# Camden Residents' Action Group

16 February 2022

**Re: DA NO: 2021/1941/1  
186 Cawdor Road, Cawdor**

*Construction and use of a recreation facility (outdoor) including site preparation works, dam dewatering, 4 x football training fields, main facility building, storage building, amenities building, associated civil infrastructure including carparking, vehicular access roads, intersection upgrades, onsite detention and water quality treatment, and perimeter and internal landscaping works including construction of a playground and BBQ area.*

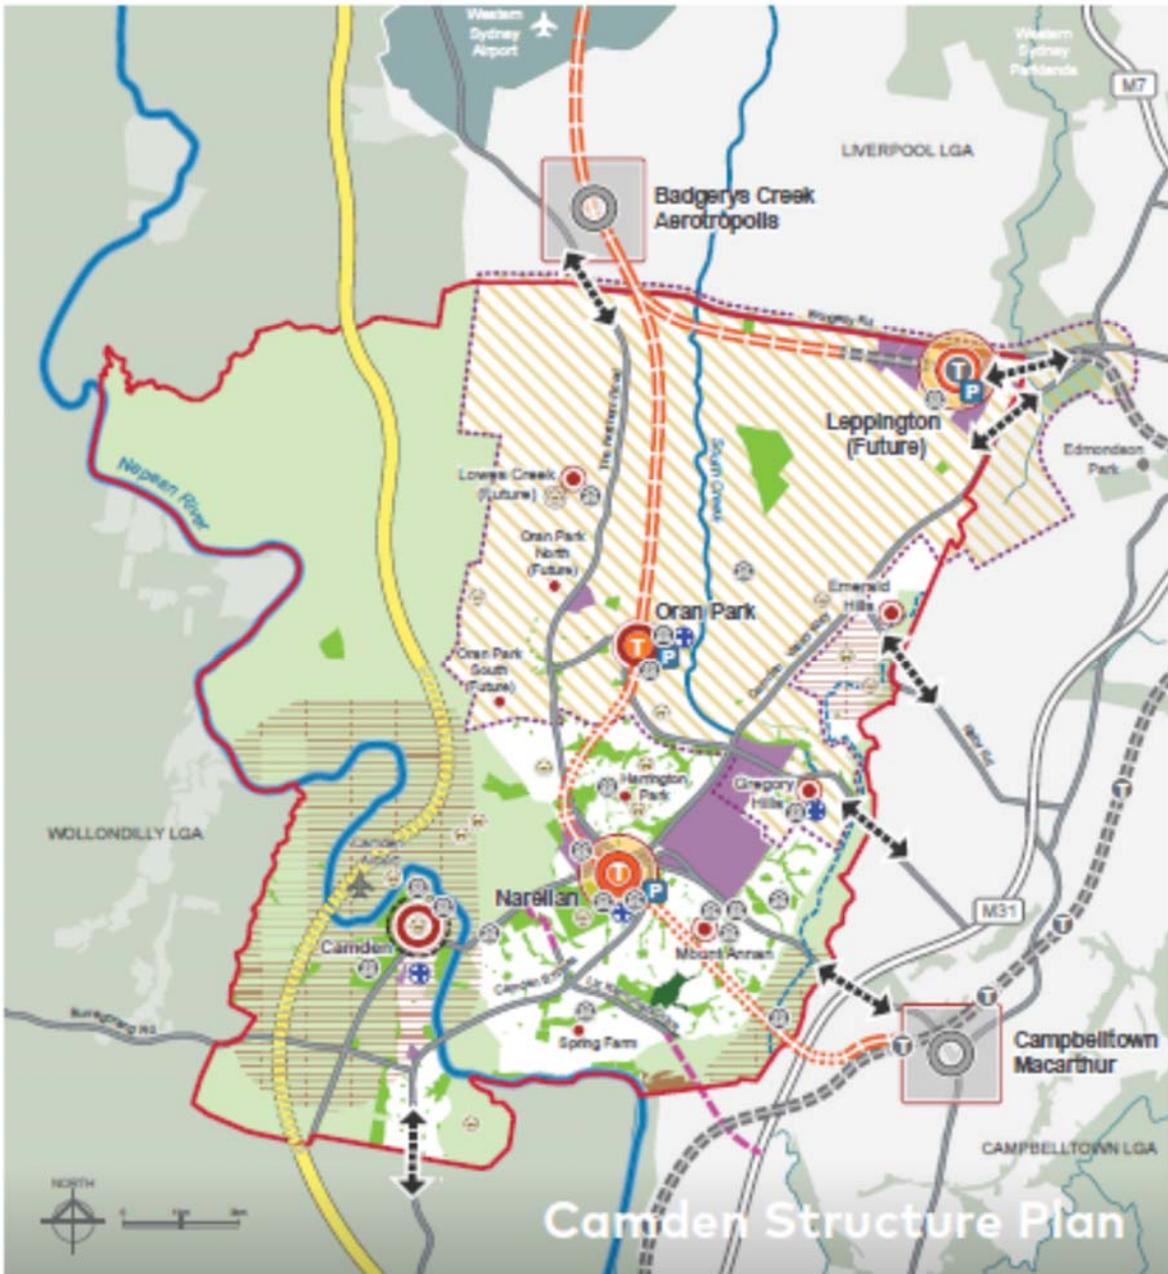
These have been incorporated most recently into the *Camden Local Strategic Planning Statement*<sup>5</sup> (LSPS) which provides a structure plan (p. 23) as shown below.

The LSPS (p. 8) reports that *rural landscapes are considered among the most valuable in the LGA and inherently tied to the local identity* and establishes the priorities of protecting Camden's rural land (S3) and scenic and cultural landscapes and views from the public realm (L2).

As shown in the Structure Plan the land in question is clearly within the area designated as Scenic Land (Metropolitan Rural Area) and the area important to the tourism economy.

Source: Advisian 21 December 2021 *Flood Impact and Risk Assessment Football Training Facility Earthworks Cut and Fill Plan* (p. 69)

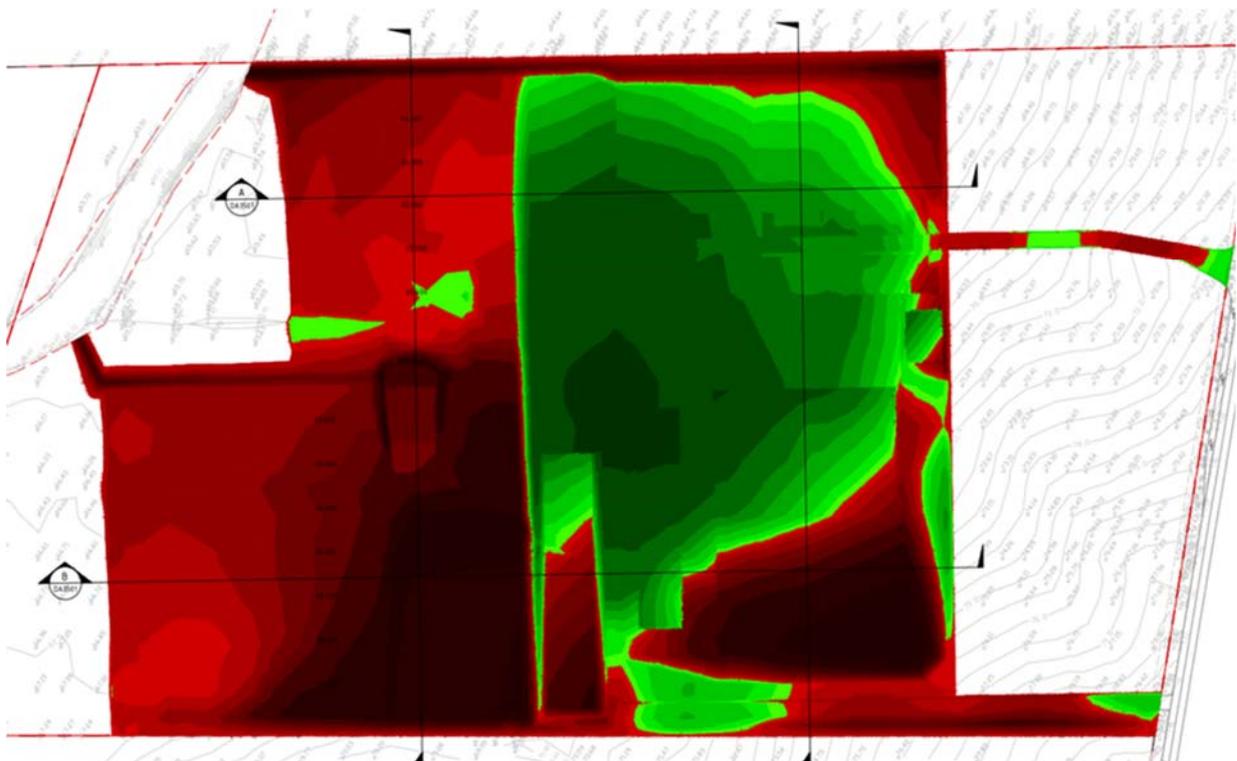
The proposed cut and fill on the site are substantial. Large areas below the 1% AEP level are to be filled.

This is not consistent with Camden's Flood Risk Management Policy (2.5)<sup>12</sup> which states that land forming and fill is not permitted below the 1% AEP flood level. It is not clear whether the Flood Impact and Risk Assessment report was, as required, prepared by a qualified engineer with suitable specialist experience or that independent certification that the land-forming will produce no adverse effects has been provided.

As shown in the diagram below the landform alterations are significant, with much of the site being cut and filled by more than 2m. There is around 100,000m<sup>3</sup>, nearly 130,000 tonnes, proposed to be moved around the site. Most disturbingly there would seem to be a drop of approximately 2.7m at the boundary which could erode quickly during a flood event, create a water-fall effect and flow beyond the site into other property. It also seems that any effect of this deep boundary cut on the small dam on the neighbouring property has not been acknowledged or addressed.
